**Mark Brown - ConceptPlanAmatil ApartmentHotel_submission Bulluss_McBride 29012012**

RE: Submission on CONCEPT of a CONCEPT PLAN for a MIXED USE RESIDENTIAL BUILDING (known as The Proposal)

Site: 71-79 Macquarie Street Sydney NSW 2000

RE: OBJECTION TO MP 10_0237 – CONCEPT PLAN APPLICATION, 71-79 MACQUARIE ST, SYDNEY

Figure 3 – Comparison to a compliant building envelope. Alterations to extracts from p 28 & 29 of the Design Report.

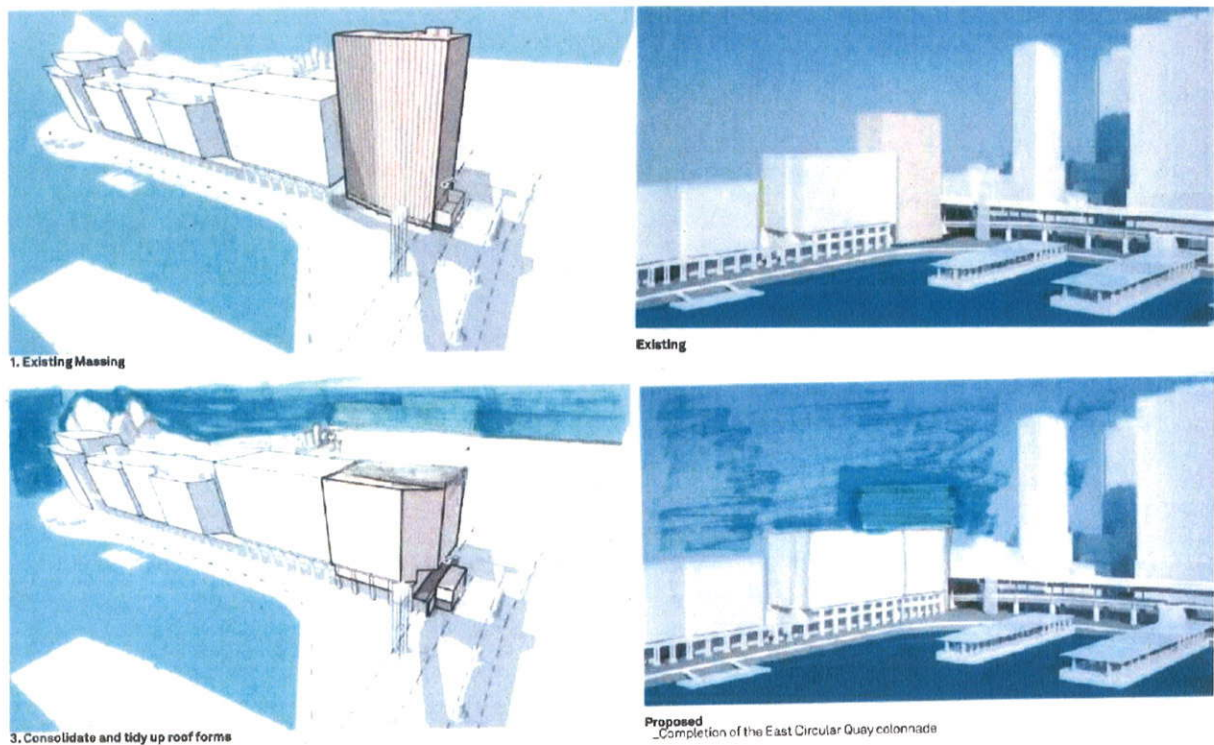
Figure 3 below demonstrates what a compliant wall development would look like and also illustrates the benefits of such a building envelope ie:

- a consistent wall development does not detract from the built form of the Opera House;
- it opens up views of the Royal Botanic Gardens and the former Government House;
- when viewed from the Sydney Cove and the Opera House the building marks the end of the Circular Quay Precinct;
- it provides a clear distinction between East Circular Quay and the CBD;
- it is in keeping with the Special Character of Macquarie Street; and
- it is a more appropriate built form adjoining the Heritage listed RACA Building.

For this reason, the Director-General should require the Concept Plan to be amended to provide a consistent wall development along East Circular Quay as enshrined in the planning controls that protect the unique and iconic significance of the Opera House, Sydney Cove, the Royal Botanic Gardens and Macquarie Street.

Figure 11 – Extract from Page 24 of the Design Report “Indicative Public Domain & Through Site Link”.

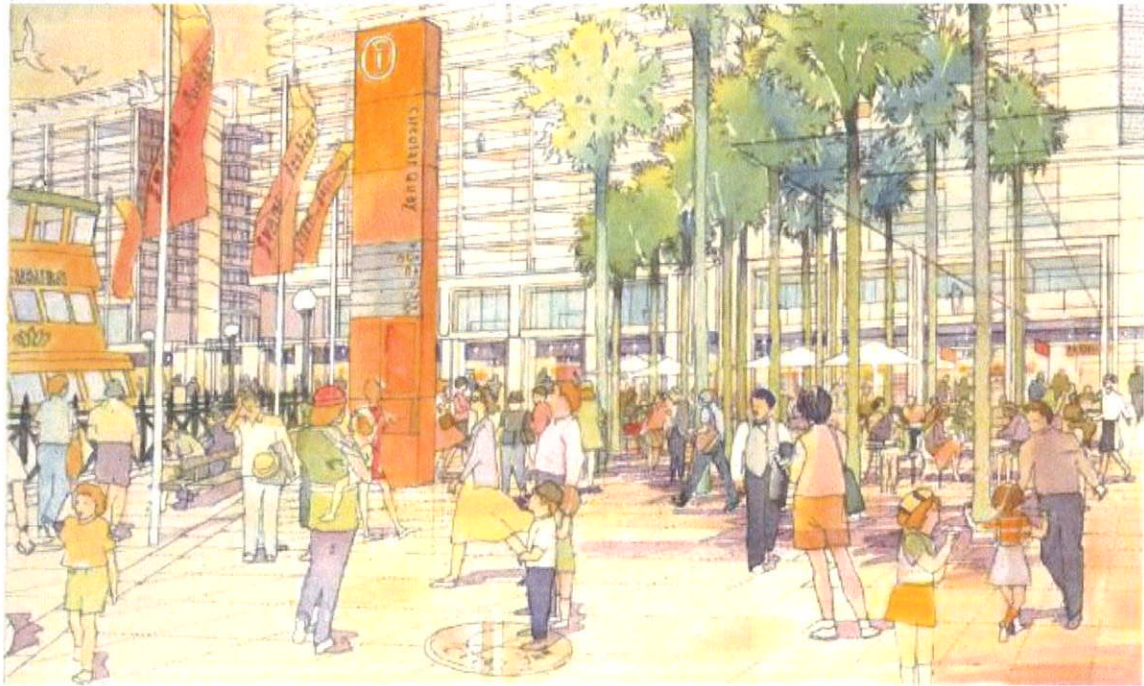
An image on page 24 of the Design Report titled “Indicative Public Domain & Through Site Link” offers a perspective of what the Public Domain will look like (reproduced at **Figure 11**).

As a comparison, a photograph has been included at **Figure 12** of the current area and it appears that there is little to no difference to the forecourt area? The EAR makes several references to public domain works to be undertaken in the forecourt adjoining the foreshore but we have little understanding of what these might be.

The Director-General should request greater level of detail regarding the public domain works including:
